# AMENDMENT 4

# Invitation for Bid (IFB) UOG IFB No. B23-01

# "INVITATION FOR MULTI-STEP SEALED BIDS FOR CONSTRUCTION SERVICES"

# **QUESTION & ANSWER SHEET 2**

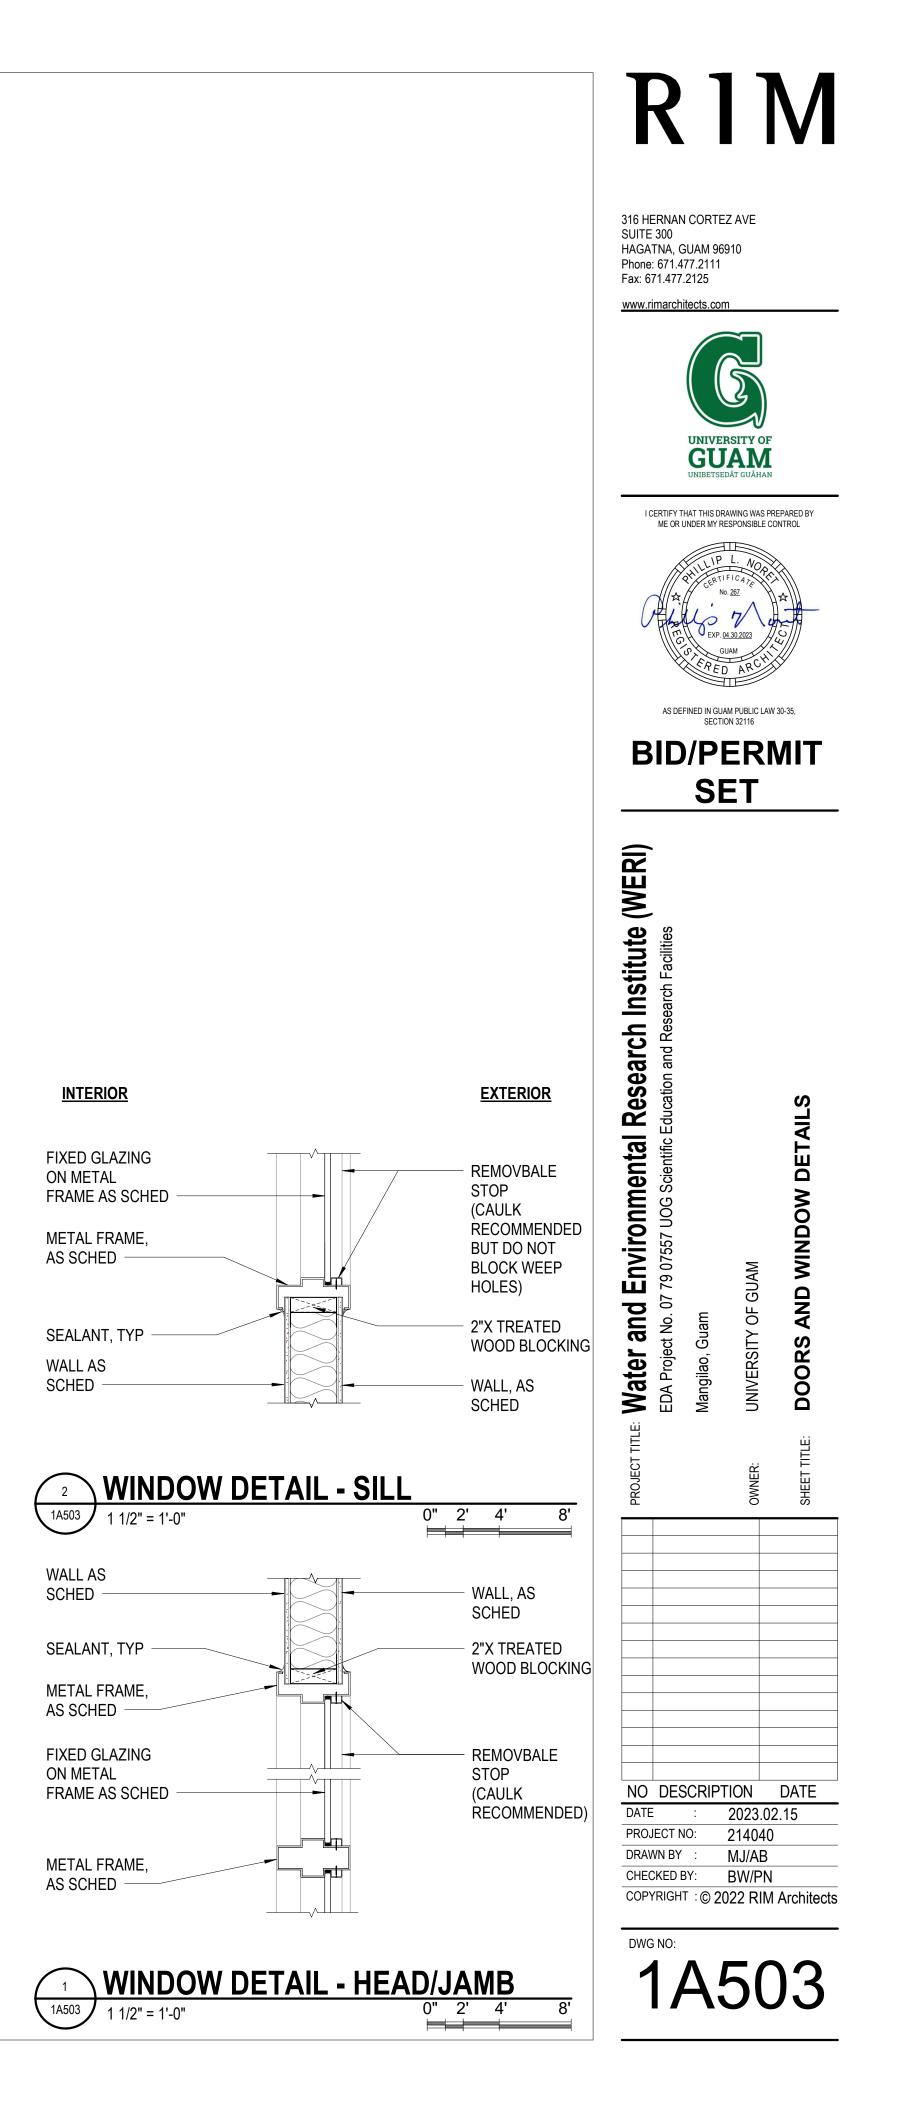
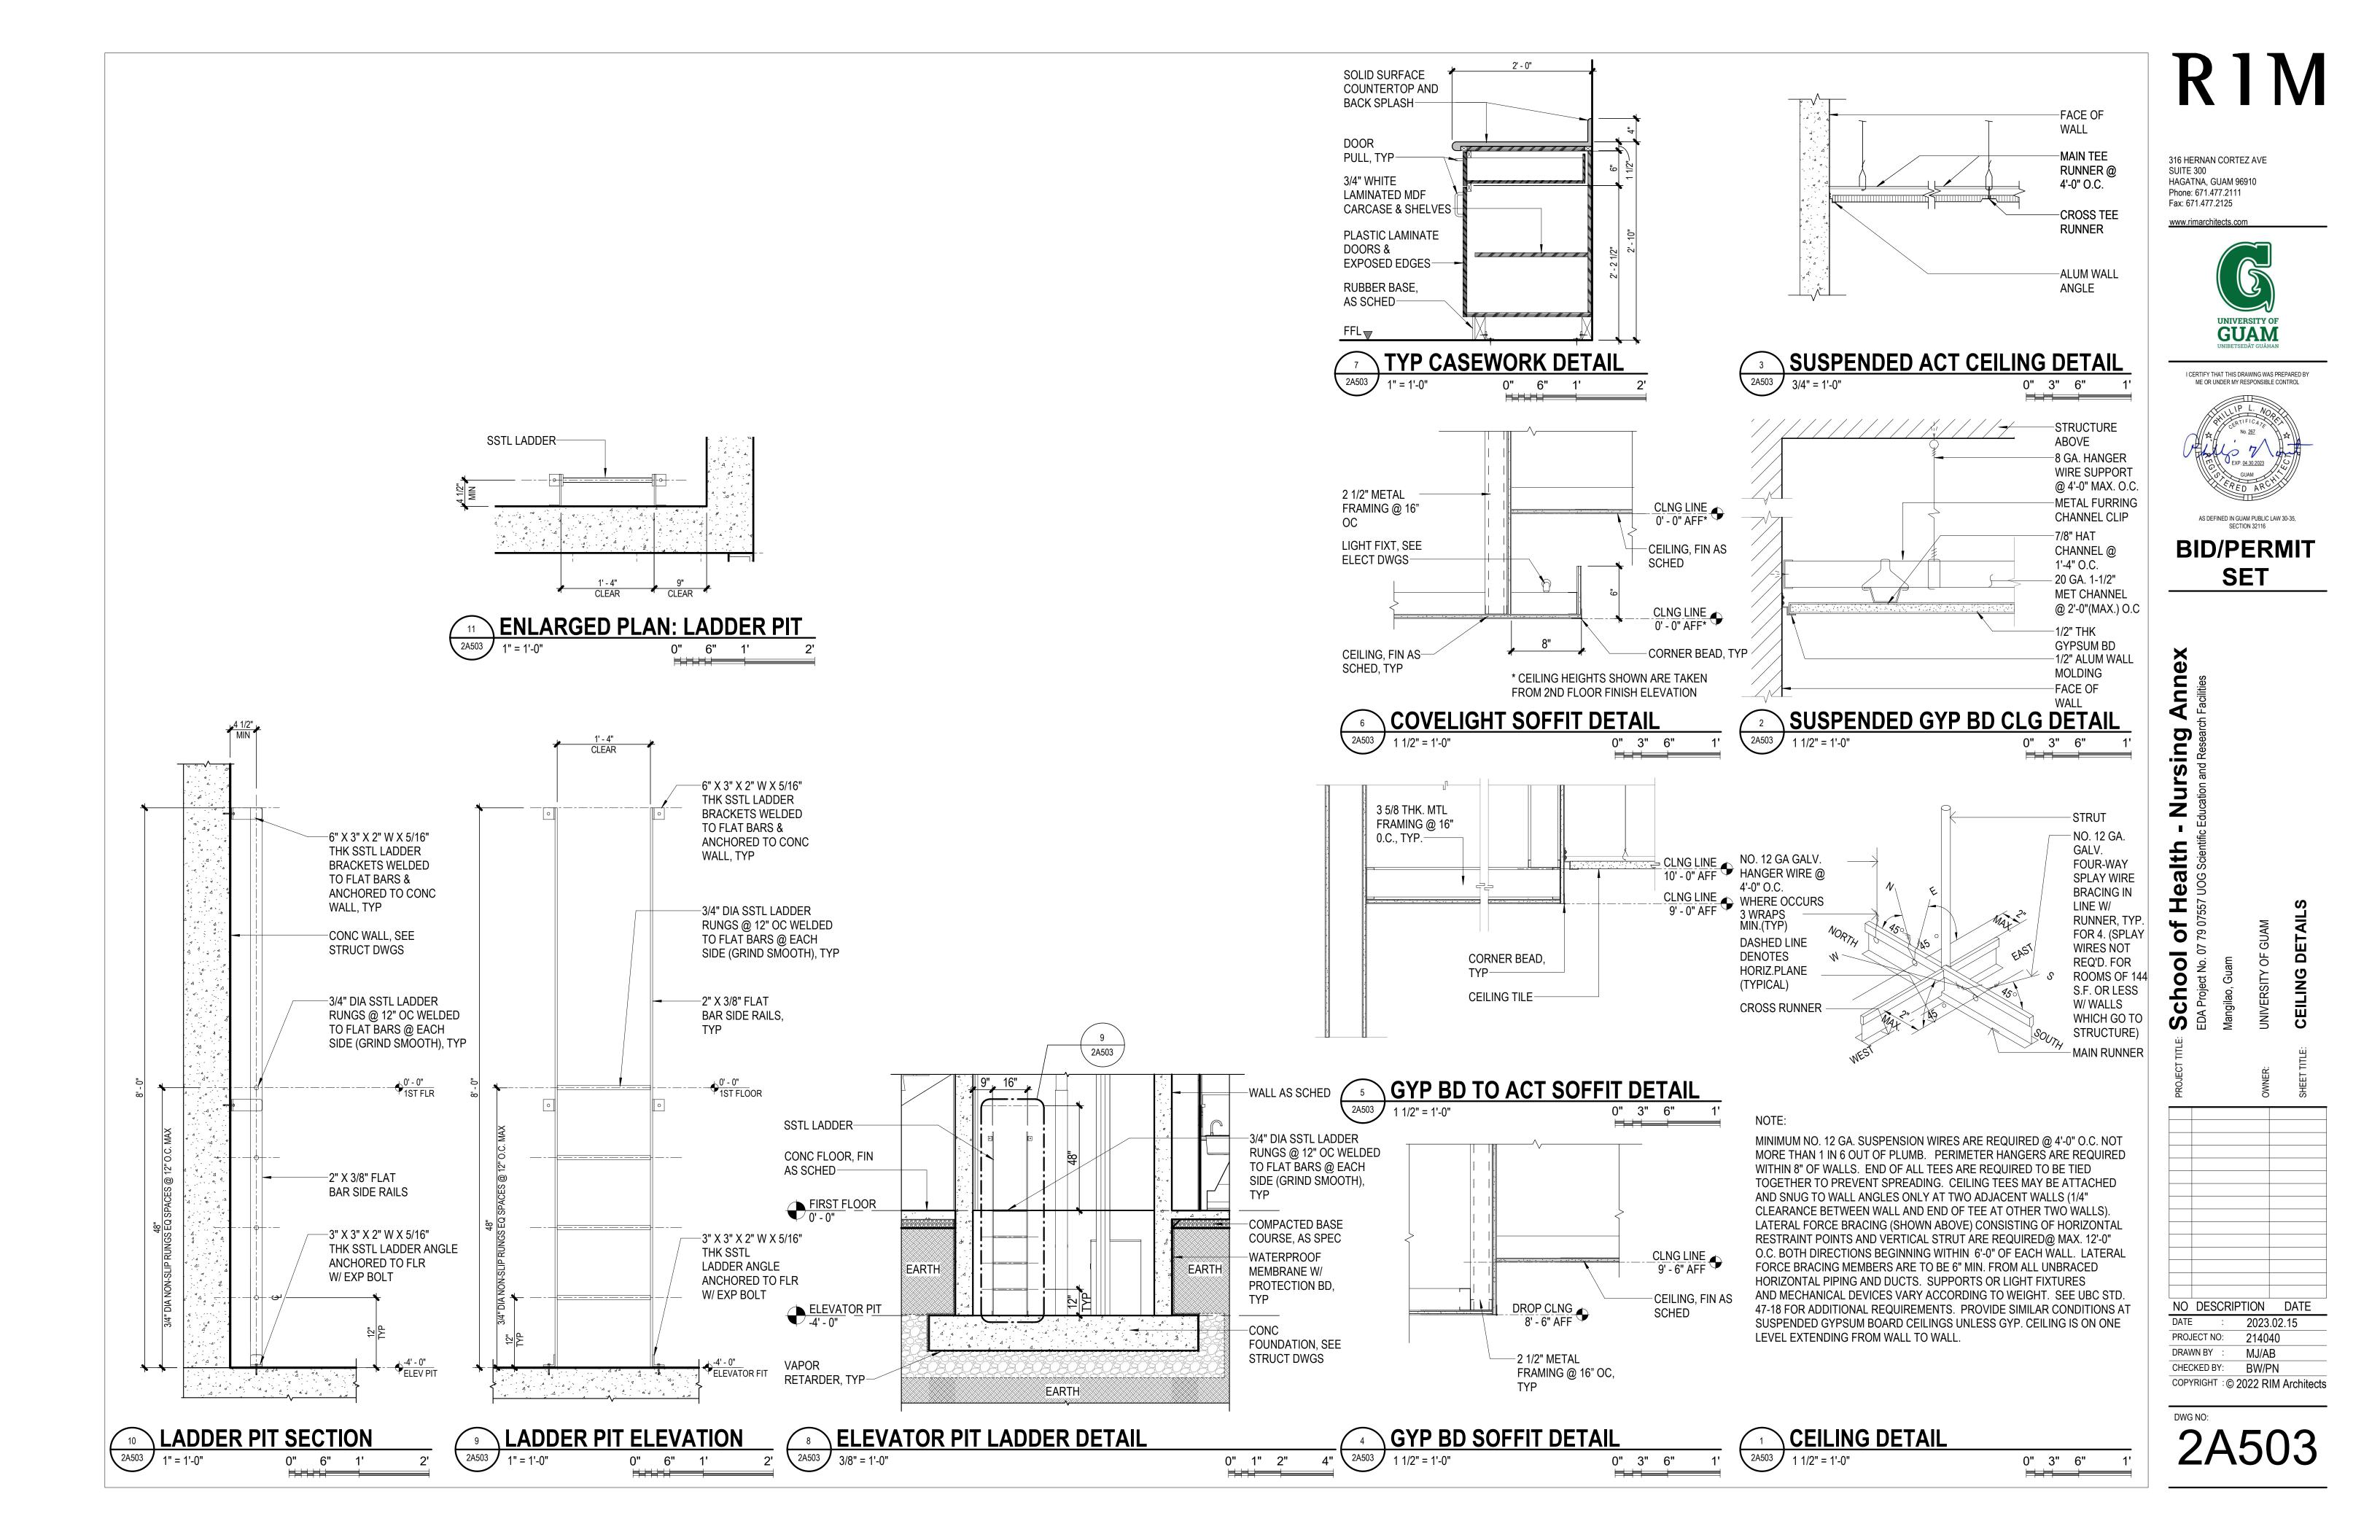
ITEM	Question
Date	6/26/23
	Responses provided 6/30/23
1	As per Drawing 1/A405, no details of the Elevator Pit Ladder. Please provide section details. Response: (RIM) Detail added. See attached.
2	Visual Display Units did not appear on the drawing. Please confirm if it is included in the bid, if yes please provide sections. Response: (UOG) These items are owner furnished. Coordinate final location with owner and provide backing in walls for mounting as needed.
3	The toilet compartment did not appear in the drawing. Please confirm if it is included in the bid, if yes please provide sections. Response: (RIM) Toilet compartments are included as shown on sheet 2A101 and 2A102 in the Men's and Women's restrooms in the Nursing Annex Building. There are no toilet compartments in the WERI Building.
4	The fire Protection Cabinet has no dimensions on the drawings. Please provide the drawing dimension. Response: (RIM) The size and dimensions of the fire extinguisher cabinet will be dependent on the size of the fire extinguisher it will encase.
